Title of Change:	Update datasheet of DIP-S6 (E4 dimension with tolerance)
Effective date:	29 May 2023
Contact information:	Contact your local onsemi Sales Office or Anh.Doan@onsemi.com
Type of notification:	This Product Bulletin is for notification purposes only. onsemi will proceed with implementation of this change upon publication of this Product Bulletin.
Change Category:	Update datasheet of DIP-S6 (E4 dimension with tolerance)
Change Sub-Category(s):	Datasheet/Product Doc change

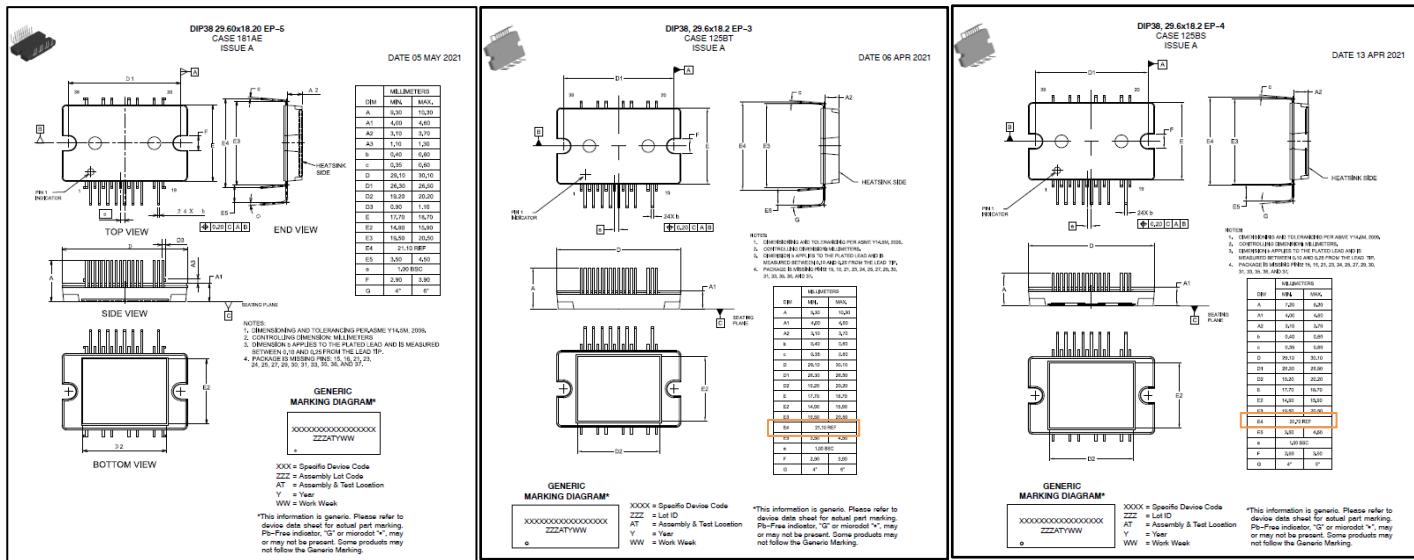
The purpose of this PB is to inform customers update datasheet of DIP-S6 (E4 dimension with tolerance). E4 dimension with tolerance 125BT, 181AE: 20.6 + 0.5mm; 125BS: 20.5 + 0.5mm.

Dimension E4 REF

Update E4 with tolerance:

125BT, 181AE:

DIM	MILLIMETERS	
	MIN.	MAX.
E4	20.1mm	21.1mm

125BS:

DIM	MILLIMETERS	
	MIN.	MAX.
E4	20mm	21mm
